# Access Compliance Report

## Public Rights-of-Way

| Intersection ID: N/A                    | Main Street: BLAKENEY PROFESSIONAL DR | Cross Street: N/A                       | Location: NE           |
| ADA ID: 04016F9D6E81                    | Ramp Type: PerpDiag                   | Initial Pass/Fail: Fail                 | Overall Compliance: No |

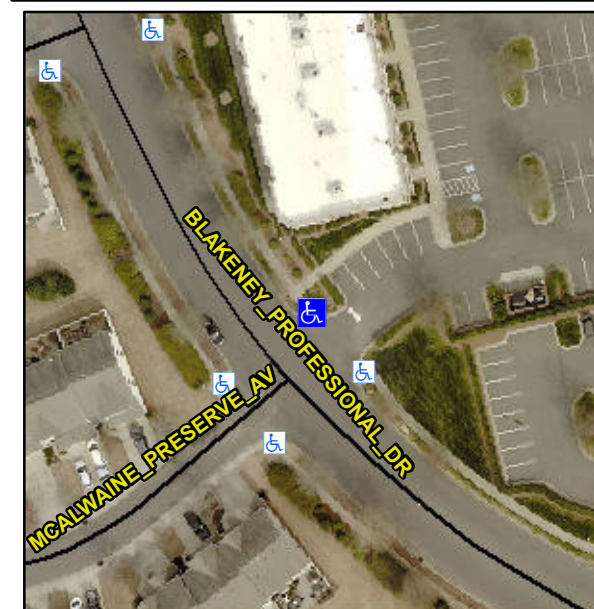
**R304.5.1**

| Compliance | Description           | Data  | Compliance | Description                 | Data  |
|------------|-----------------------|-------|------------|-----------------------------|-------|
| No         | Ramp Width (in)       | 37.0  | Yes        | Ramp XSlope (%)             | 2.0   |

**Remove & Replace Curb Ramp With Two New Directional Ramps or Equivalent.**
